CITY OF NOVI CITY COUNCIL
MAY 19, 2025

SUBJECT: Initial review of eligibility of Mariella Estates, JZ24-43, to rezone property north of Eight Mile Road, west of Garfield Road, from Residential Acreage to R-1 One Family with a Planned Rezoning Overlay.

JZ24-43 MARIELLA ESTATES

BRACIOLE BROTHERS, LLC
MARELLA ESTATES
CONCEPTUAL PLANNED
REZONING OVERLAY
LAYOUT PLAN

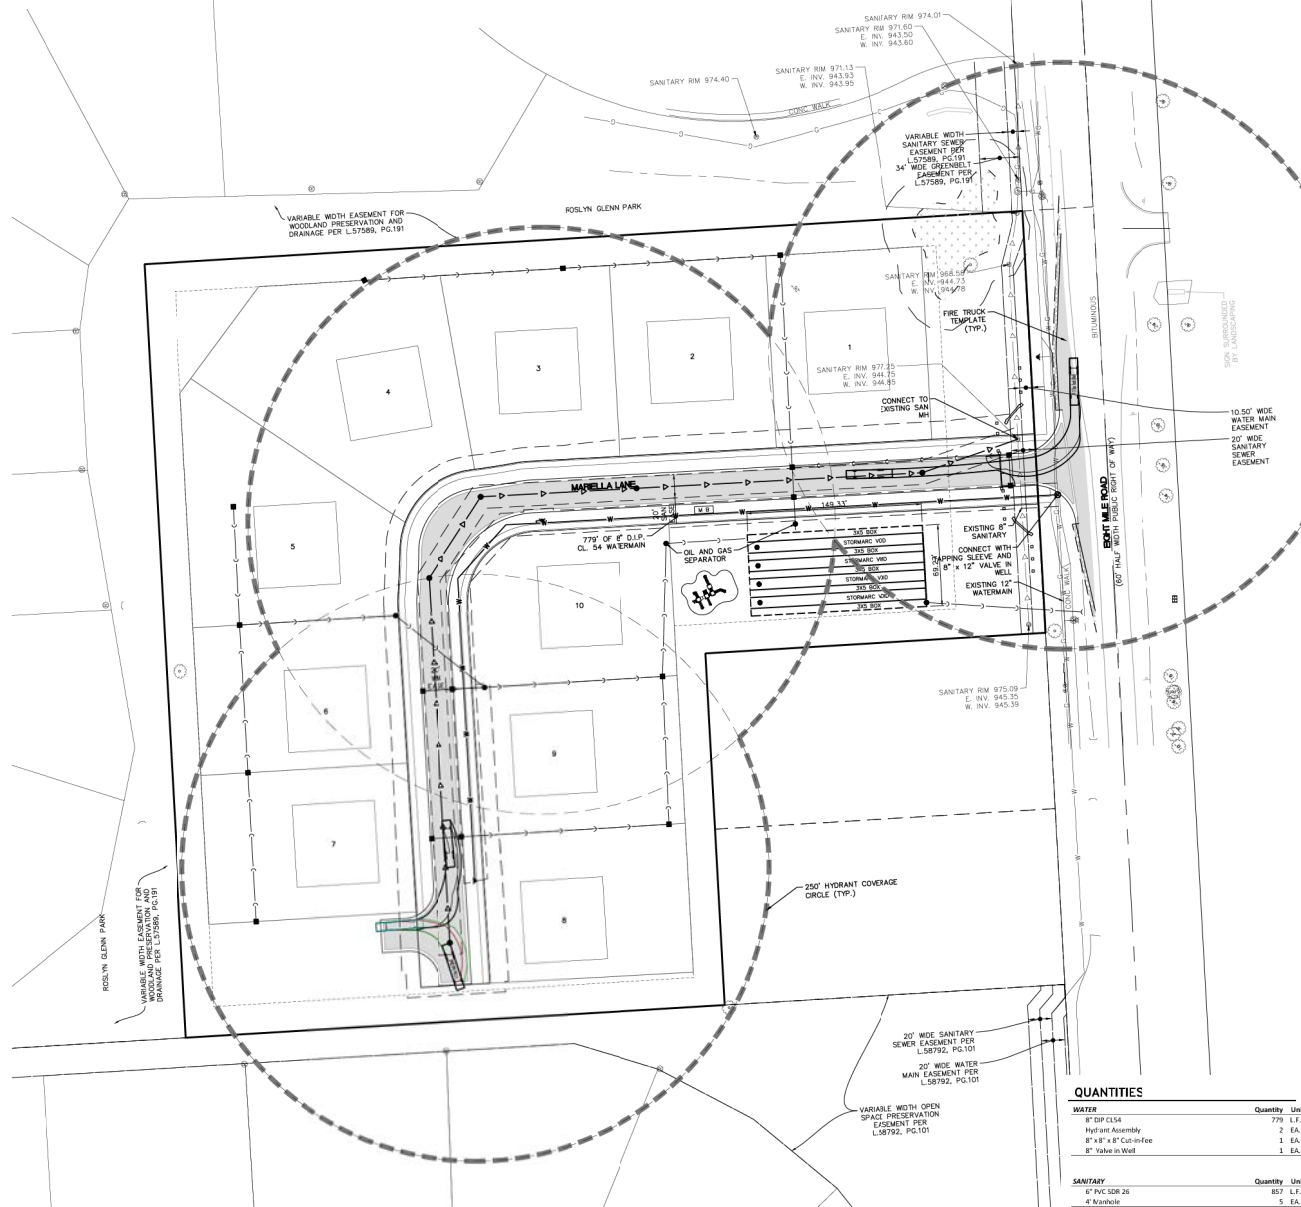
3. Sheet 04 Layout Notes state that the road will not be gated and that roads will be private, the plan shows a gate at the entrance and the road is labeled with 60' ROW. Clarify if roads will be private, revise note to state 60' private road ROW.

Response: *Understood. Following the results of the PC meeting the plans will be submitted to RCOC for review/approval.*
3. Sheet 04 Layout Notes state that the road will not be gated and that roads will be private, the plan shows a gate at the entrance and the road is labeled with 60' ROW. Clarify if roads will be private, revise note to state 60' private road ROW.

BRADJOE BROTHERS, LLC
MARELLA ESTATES
CONCEPTUAL PLANNED
REZONING OVERLAY
UTILITY PLAN

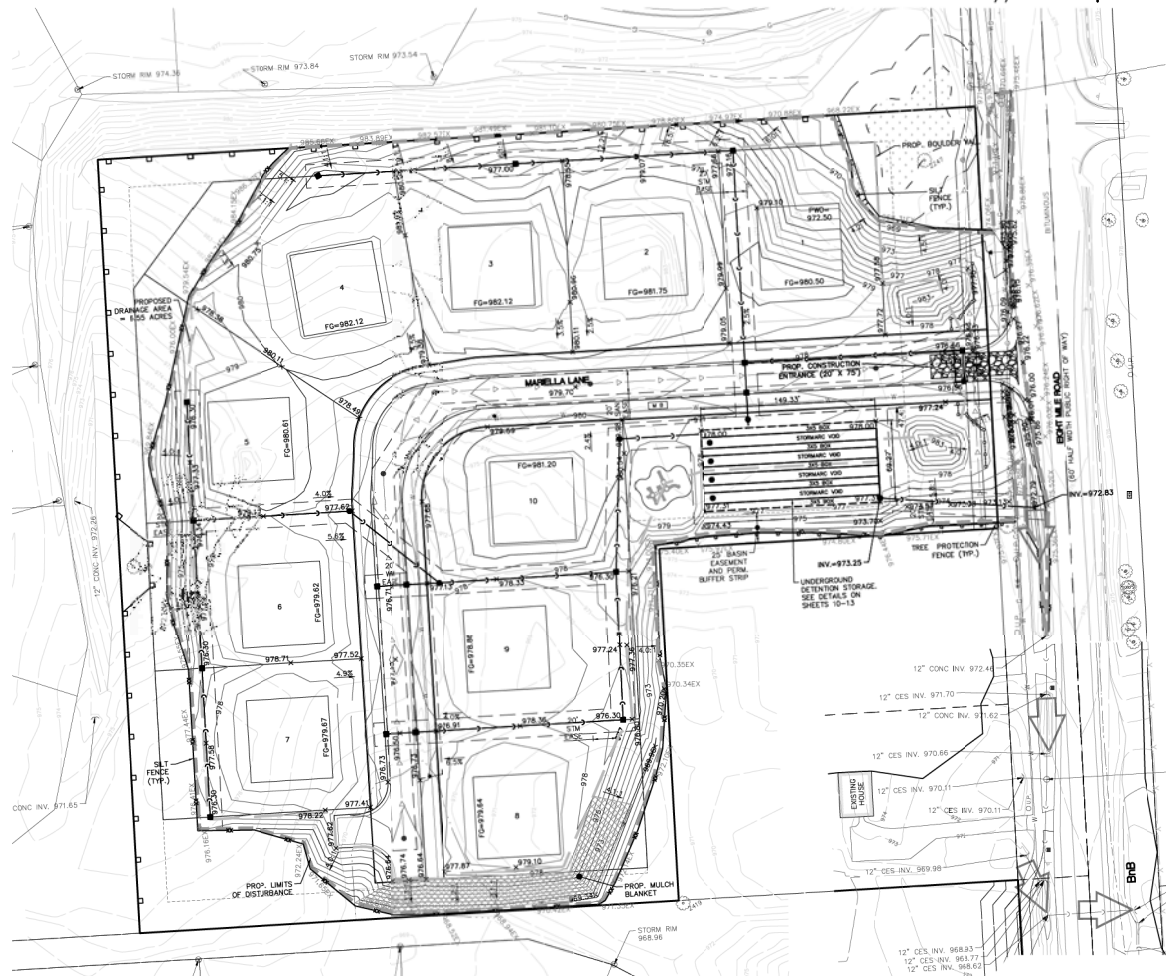
- **All fire hydrants *MUST* be installed and operational prior to any combustible material is brought on site. *IFC 2015 3312.1.* *ONE additional hydrant is needed near lot #1. Sheet #5 only shows 2 hydrants being added to new water main.***

Sheet #5 indicates 45’ turning radii. Have this updated and include 50’ turning capabilities.
- ***All other Fire Department notes (from sheet 1) will be followed for next review.***

1. All fire hydrants MUST be installed and operational prior to any combustible material is brought on site. IFC 2015 3312.1. ONE additional hydrant is needed near lot #1. Sheet #5 only shows 2 hydrants being added to new water main.

3. Fire apparatus access drives to and from buildings through parking lots shall have a minimum fifty (50) feet outside turning radius and designed to support a minimum of thirty-five (35) tons. (D.C.S. Sec 11-239(b)(5)). Sheet #5 indicates 45' turning radii. Have this updated and include 50' turning capabilities.

Response: *Emergency vehicle turning movement is shown on sheet 5.*

BRAGIOLE BROTHERS, LLC
MARELLA ESTATES
CONCEPTUAL PLANNED
REZONING OVERLAY
GRADING & STORM WATER MANAGEMENT PLAN

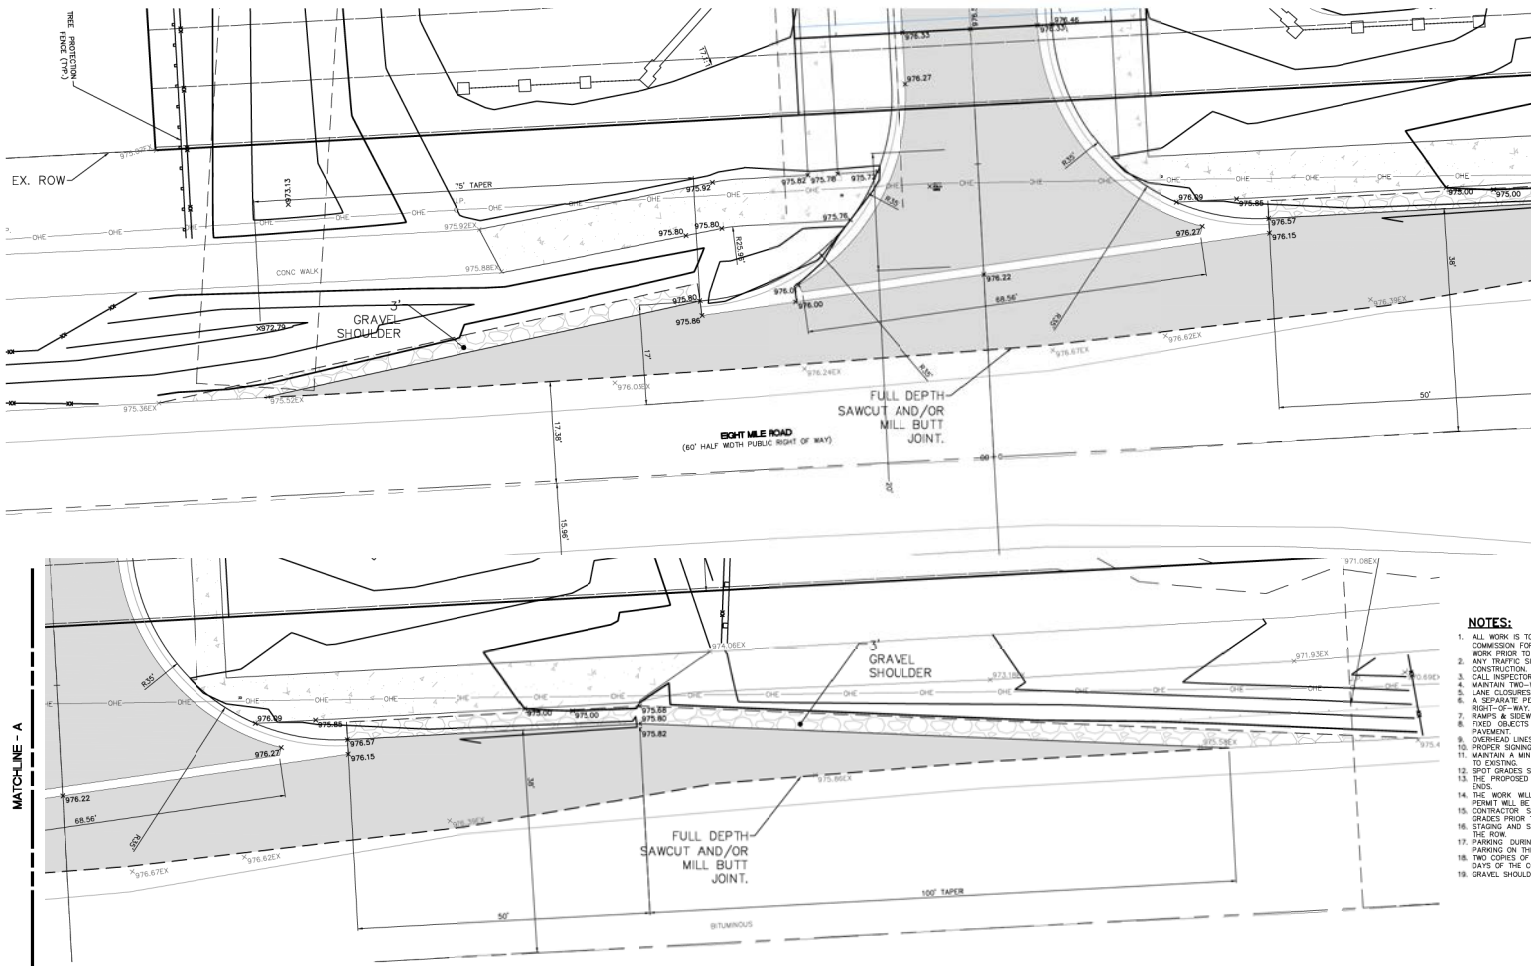
- ii. Sheet 06 contains a label pointing to a proposed boulder wall that is unclear of the extent of the boulder wall. It is requested that in future submittals (once the current boundary is established) that symbols are provided showing the extent of the proposed boulder wall. Additionally, fill information (cubic yards and square feet) will be required for potential impacts to the feature and its setback.

- ii. Sheet 06 contains a label pointing to a proposed boulder wall that is unclear of the extent of the boulder wall. It is requested that in future submittals (once the current boundary is established) that symbols are provided showing the extent of the proposed boulder wall. Additionally, fill information (cubic yards and square feet) will be required for potential impacts to the feature and its setback.

Response: *Pre/Post runoff calculations have been added to sheet 6.*
29. The SWMP must address the discharge of storm water off-site, and evidence of its adequacy must be provided. This should be done by comparing pre- and post-development discharge rates. The area being used for this off-site discharge should be delineated and the ultimate location of discharge shown.

Response: *Pre/Post runoff calculations have been added to sheet 6.*
30. An adequate maintenance access route to the basin outlet structure and any other pretreatment structures shall be provided (15 feet wide, maximum running slope of 1V:5H, maximum cross slope of 3%, and able to withstand the passage of heavy equipment). Verify the access route does not conflict with proposed landscaping.

Response: *The plan has been revised to show slopes at 1V:4H or flatter. There is one smaller area on the west side of lot 8 that still must be steeper than 1V:4H, but this slope is designed flatter than 1V:3H, is constructable, is mowable, and will be established using a mulch blanket additional BMP measure. Refer to sheet 6.*

Response: *Tree protection fence has been added and is shown on sheet 06.*

Figure 1 – City of Novi Woodlands and Wetlands Map
Attachment A – Aerial Imagery
Attachment B – Site Photographs

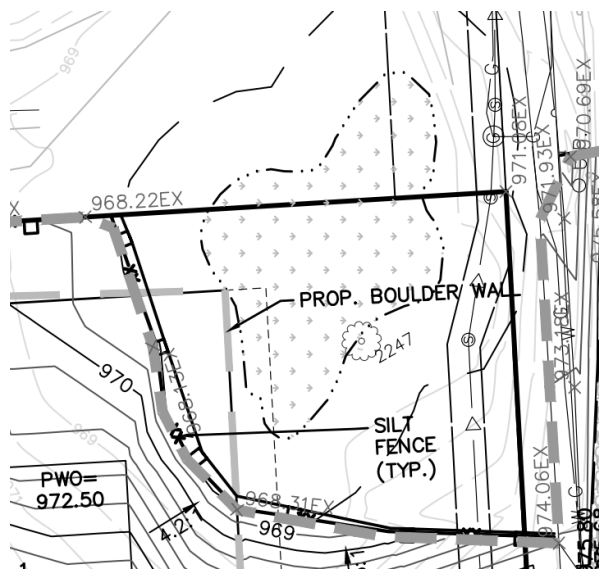
Merjent reviewed the plans for conformance with the City of Novi's (City) current Wetlands and Watercourse Protection Ordinance, Chapter 12 Article V. The site is located approximately at 49680 Eight Mile Road in Section 31 of the City (Parcel No. 50-22-31-400-008). The site contains City-regulated wetlands (**Figure 1**).

- ☒ City-regulated wetlands, as identified on the City of Novi interactive map website. Note that both wetland and property limits depicted on the City's map are considered approximations (**Figure 1**). Although not depicted on the City of Novi's interactive regulated wetland map viewer (**Figure 1**), this should be used as an initial planning tool and does not constitute the presence or absence of City-regulated wetlands.
- ☐ Wetlands that are regulated by the Michigan Department of Environment, Great Lakes, and Energy (EGLE).
